# ELEMENTAL

## PERMIT SET

Michael Moore, MO Architect #2099932812  
Project Number: 2510  
Project Type: TENANT FINISH  
Project Name and Address:

**ELEMENTAL**  
624 NE Maguire Blvd  
Lee's Summit, Missouri 64064

PARTITION TYPE A-1

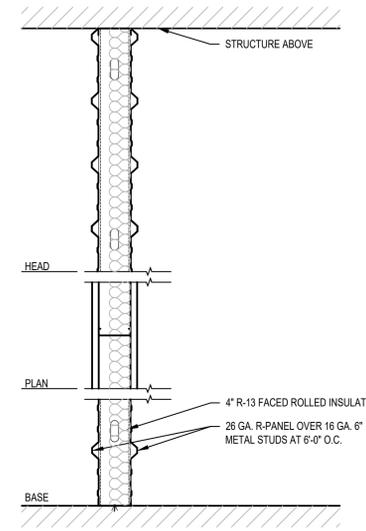
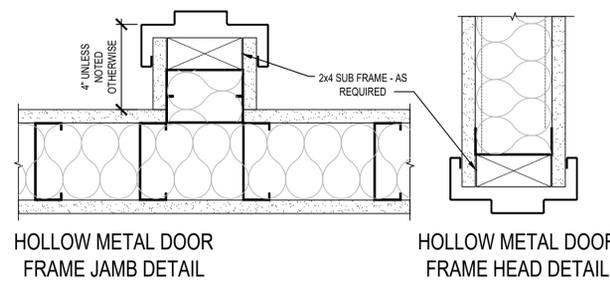
COMMENT #1: WALLS WITHIN 2' OF SERVICE SINKS, URINALS, AND WATER CLOSETS MUST BE PAINTED WITH EPOXY-BASED PAINT UP TO A MINIMUM OF 4' A.F.F.
